Docket Item # 2  
BAR CASE # 2011-0279

BAR Meeting  
October 26, 2011

**ISSUE:** Fencing and Waiver of Height Requirement

**LOCATION:** 1119 and 1119 ½ Queen Street

**Figure 1. Photo showing fencing prior to renovation.**

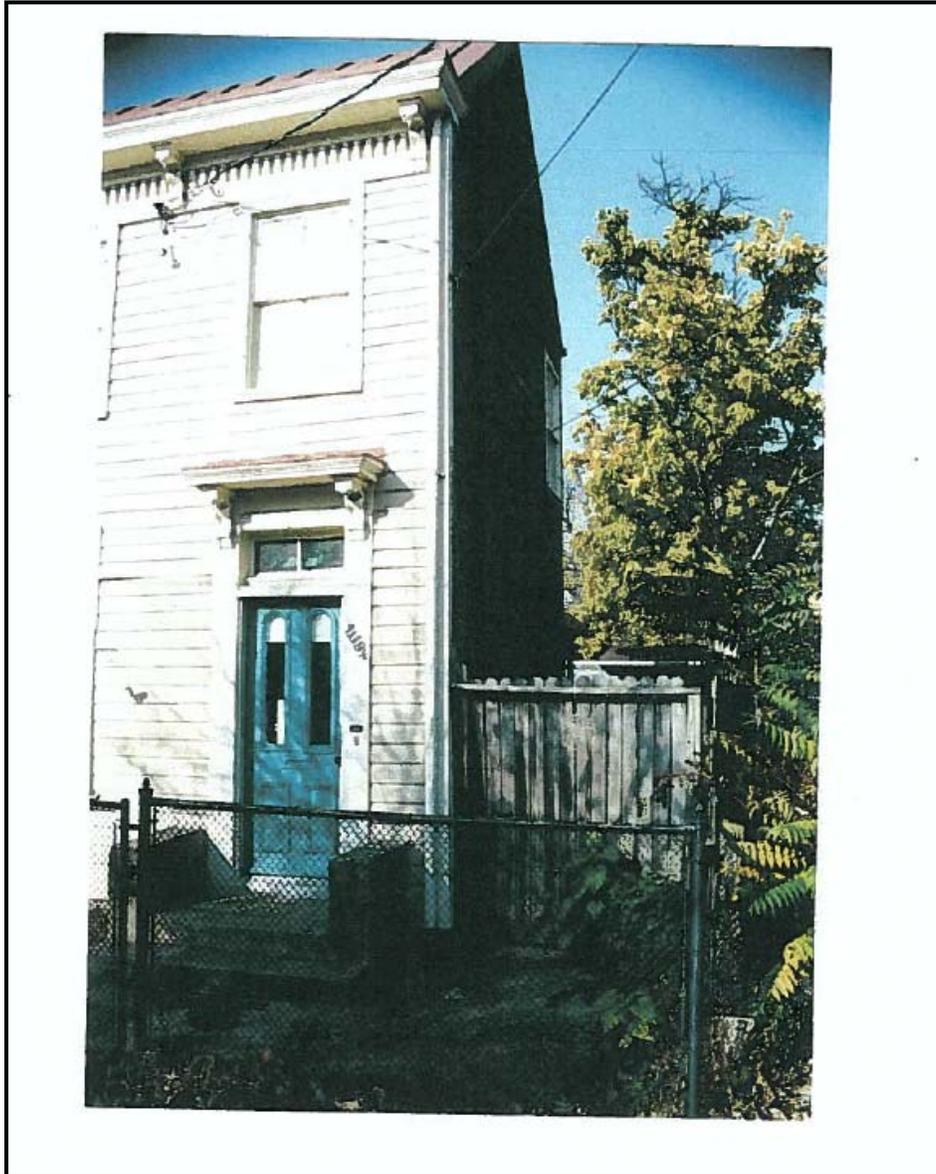
Both of the fence types proposed by the applicant along Queen Street – decorative iron or stained wood – are appropriate in the historic district and recommended in the *Design Guidelines*. However, Staff supports the increased height for the solid wood fence *only* if it does not project beyond front plane of the house. The fence should either be located in line with the proposed wood gate adjacent to the house (11 feet from the property line), or the front of the house (8 feet from the property line), as it was previously located (see photo in Figure #1 provided by the applicant).

1. That the 6 foot tall wood fence be located at or behind the front building wall; and,
2. That the decorative iron fence be extended to incorporate the front of the vacant lot.

Figure 5. Proposed fence details.

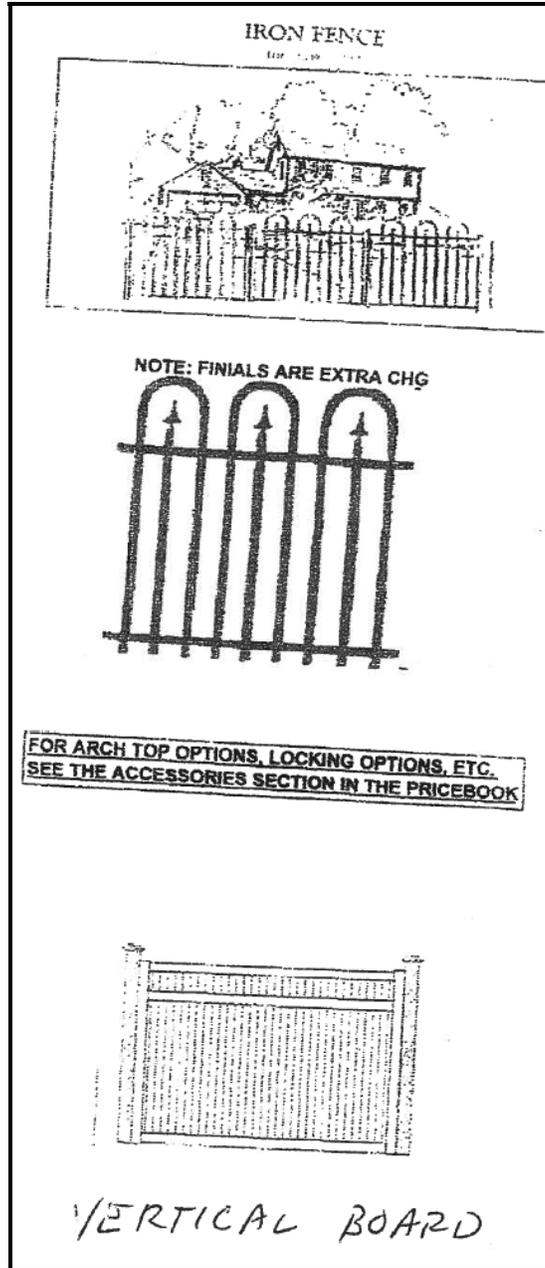
In addition, Staff also recommends that the decorative iron fence incorporate the front of both of the applicant's lots, allowing the front garden to grow beyond the front of the house (see Figure 6 for an example nearby of a front garden enclosed by a decorative iron fence). This will allow the
